SUBJECT: Announcement of Public Hearing – Concept Development Plan Approval – The Pavilions of Troy Planned Unit Development (PUD 9) – Northwest corner of Big Beaver and Coolidge, Section 19 – O-S-C, O-M and P-1 Districts

Planned Unit Development/Site Plan Review For City of Troy, Michigan

Applicant	Richardson Development Group
Project Name:	Pavilions of Troy PUD
Plan Date:	September 5, 2007
Latest Revision:	August 28, 2007
Location:	Northeast corner of Big Beaver and Coolidge
Zoning:	O-S-C Office Service Commercial, O-M Office Medical, and P-1 Vehicle Parking
Action Requested:	<p>Planning Commission review and recommendation to the City Council for approval of the Concept Development Plan. The procedure for review and approval of a PUD is a three-step process.</p> <ul style="list-style-type: none">• The first step is an application for and approval of a Concept Development Plan, along with a Development Agreement. The Concept Development Plan and Development Agreement are approved by the City Council following recommendation of the Planning Commission. Such action, if and when approved, shall confer upon the applicant approval of the Concept Development Plan and shall rezone the

Pavilions of Troy Road System & Circulation Plan - Phase 1

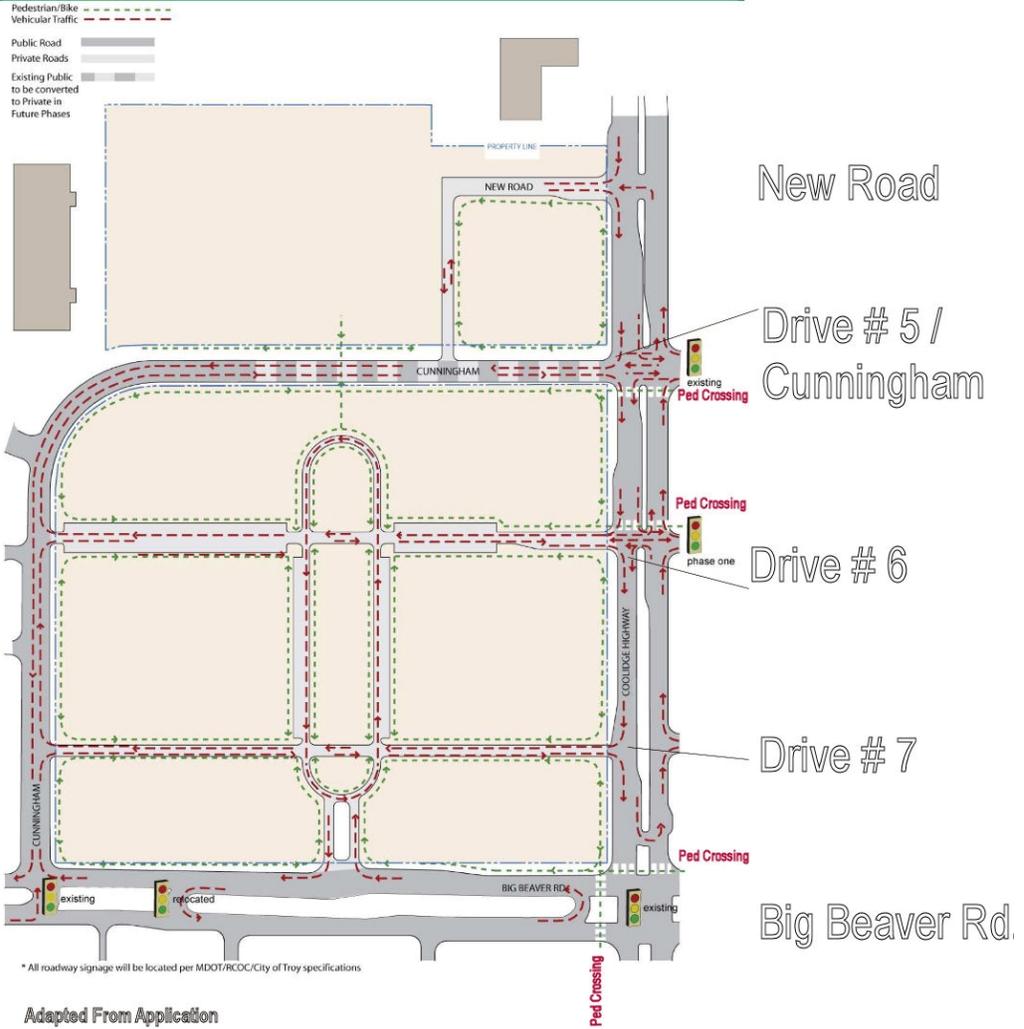
3. Along the east-west portion of Cunningham, there is proposed to be a single drive on the south side that will access a proposed parking garage (Figure 1). Three driveways are also proposed on the north side of Cunningham serving individual buildings and the grocery store parking lot.

Pavilions of Troy Road System & Circulation Plan - Buildout

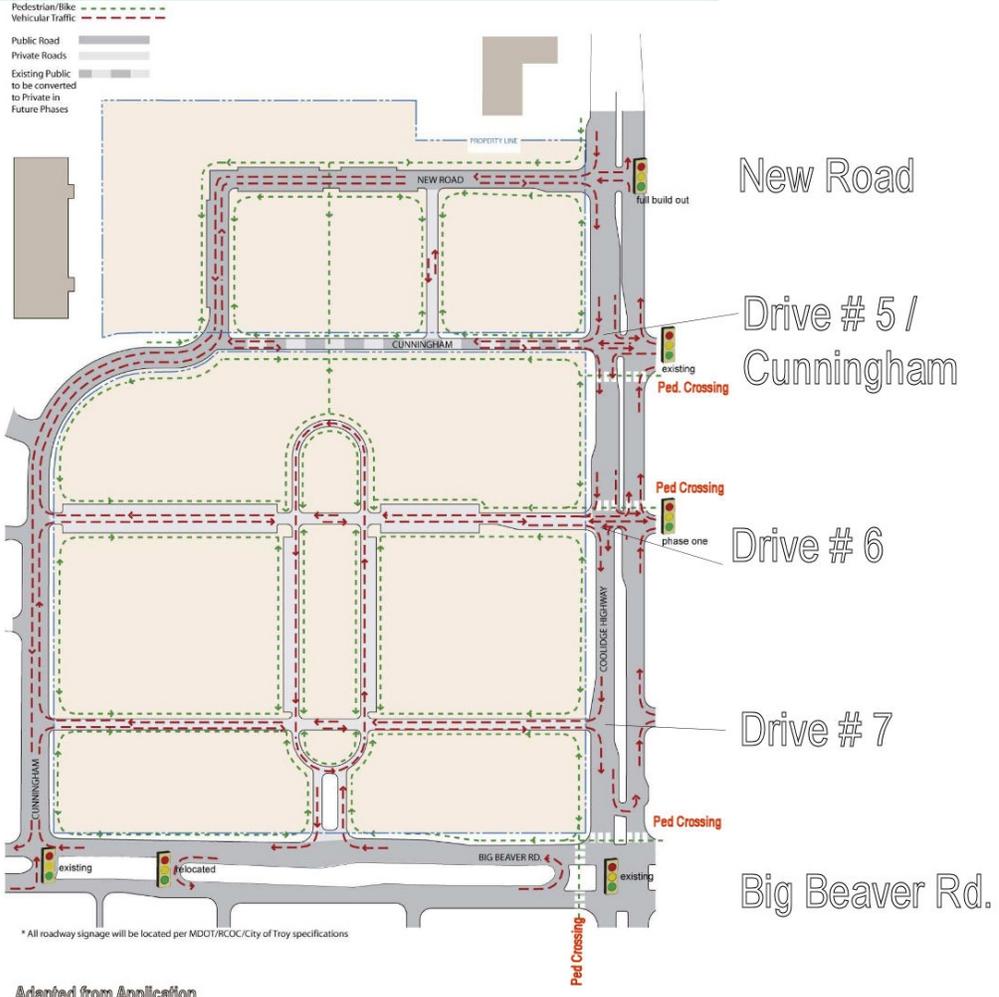
2. As part of Phase 2 (buildout), the function of Cunningham at Coolidge will be modified to eliminate all eastbound left turns. These will be shifted north to the New Road intersection with Coolidge (see Figure 3).

4. All major roadways in the Pavilions will have pedestrian paths on both sides, as shown on Figure 3 (green dashed lines). As noted in the Application, this is proposed to be a walkable development, with pedestrian linkages through. Connections are also to be provided to the existing path system along Big Beaver Road and Coolidge Highway. On-street parking will be provided on many internal roads, creating a buffer between moving traffic and pedestrian pathways.
